Reference: Pennsylvania State University Breazeale Nuclear Reactor
Docket No. 50-005, License No. R-2
USNRC Request for Additional Information (RAI) dated September 9, 2008

Subject: Response to RAI

PSU RESPONSE TO NRC RAI

Wind Class Frequency Distribution

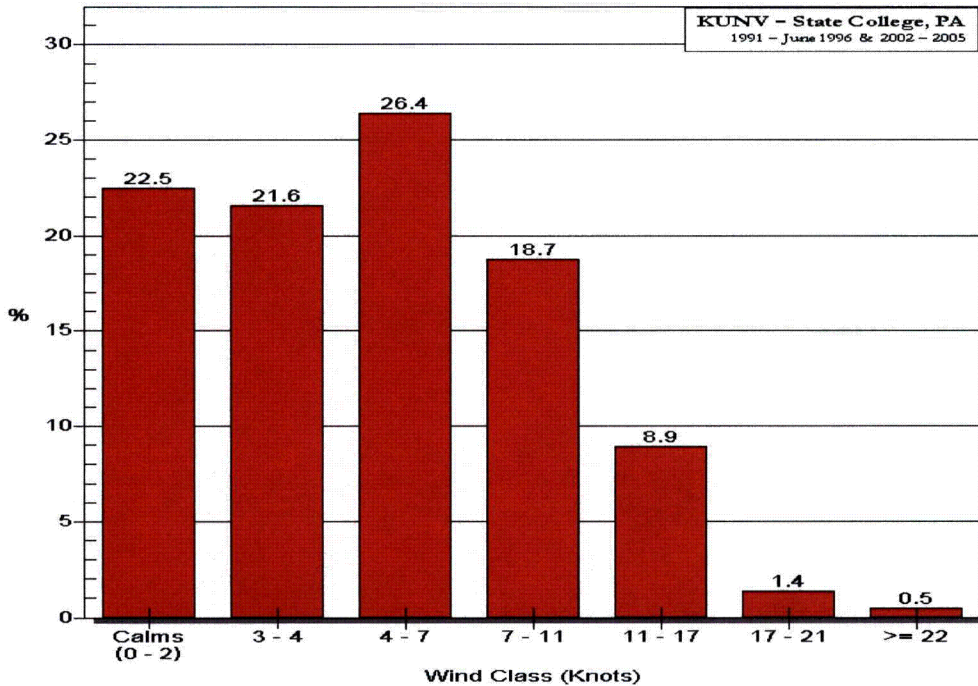
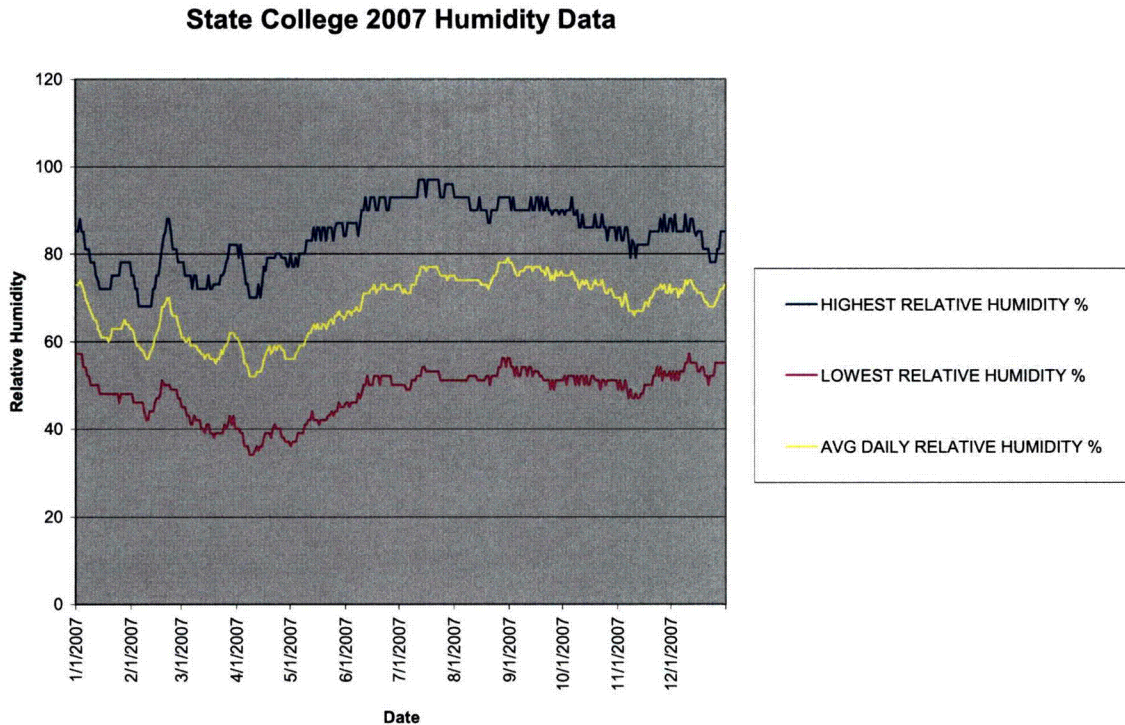
2.1 General meteorological information for the site, other than extremes, is not included in the description of site characteristics. Provide site information on temperature ranges, humidity, and average wind speed, or justify its exclusion.

Typical wind direction and speed distributions can be interpreted from the two figures below. (Source Office of State Climatologist website)

Relative humidity data for 2007 is shown graphically below and represents typical variations.

Figure 13 from DOE Fundamentals Handbook, Thermodynamics, Heat Transfer, and Fluid Flow, Volume 2 of 3

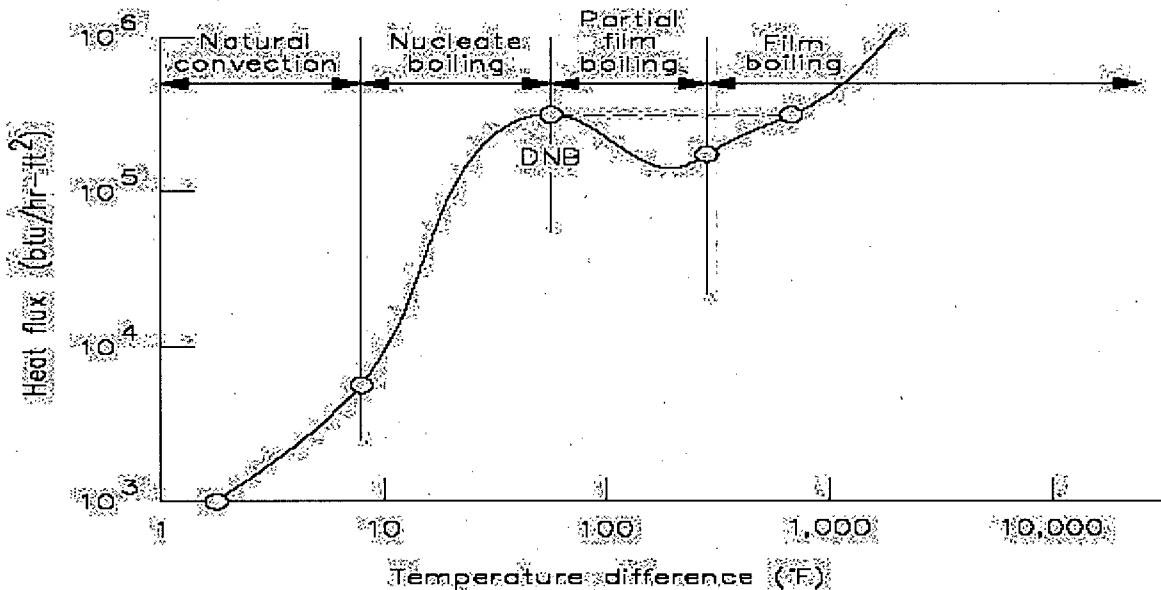
4.8 Section 4.6, Thermal-Hydraulic Design, Page IV-25. Provide a thermal-hydraulic analysis of the PSBR to demonstrate that natural convection provides adequate cooling to maintain clad temperatures below 500 °C, as stated in the basis for the fuel temperature safety limit of 1150 °C. Include a discussion of the analysis methods and correlations used to determine the minimum Critical Heat Flux Ratio (CHFR) for steady-state and transient operation (including the reactivity insertion accident). (Reference: "TRIGA Reactor Thermal-Hydraulic Study," TRD 070.01006.04, Rev. A.)

The figure below shows the behavior of pool water as the heat flux rises. (DOE-HDBK-1012/2-92 DOE Fundamentals Handbook, Thermodynamics, Heat Transfer, and Fluid Flow, Volume 2 of 3). The figure illustrates the small cladding temperature rise and change (less than 60 °C) for the large heat flux (over a factor of 10) between the onset of nucleate boiling and the departure from nucleate boiling or Critical Heat Flux (CHF).

Therefore as long as the reactor stays in a region of sub-cooled nucleate boiling, cladding temperature will be closely tied to saturation temperature (at ~2 atmospheres) in the core and the cladding will stay below 500°C as stated in the SAR. If the heat flux reaches CHF, cladding temperatures will rise rapidly.

Figure 14 from GA-6216 *Characteristics of Large Reactivity Insertions in a High Performance TRIGA U-ZrH Core*

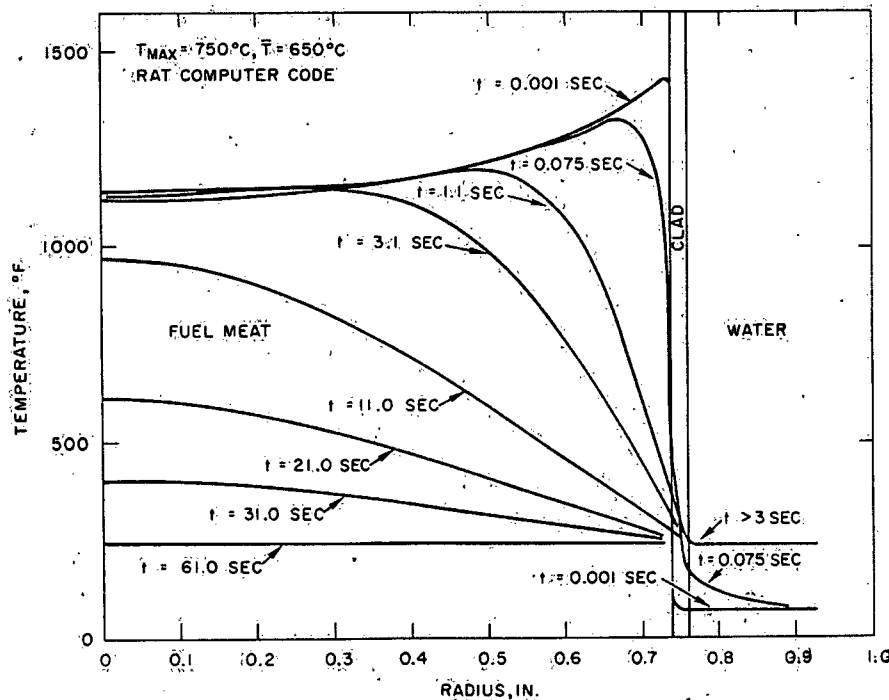
13.2 Section 13.1.A, TRIGA Fuel Temperature Analysis of the PSBR. Explain how the measured-to-peak fuel temperature factor of 1.6 for pulses is derived from the profile described by Equation 4 and the parameters in Table 13-1.

This behavior is shown in Figure 14 from the document *GA-6216 Characteristics of Large Reactivity Insertions in a High Performance TRIGA U-ZrH Core*. It shows that the peak temperature is at approximately 89% of the fuel radius immediately following the pulse.
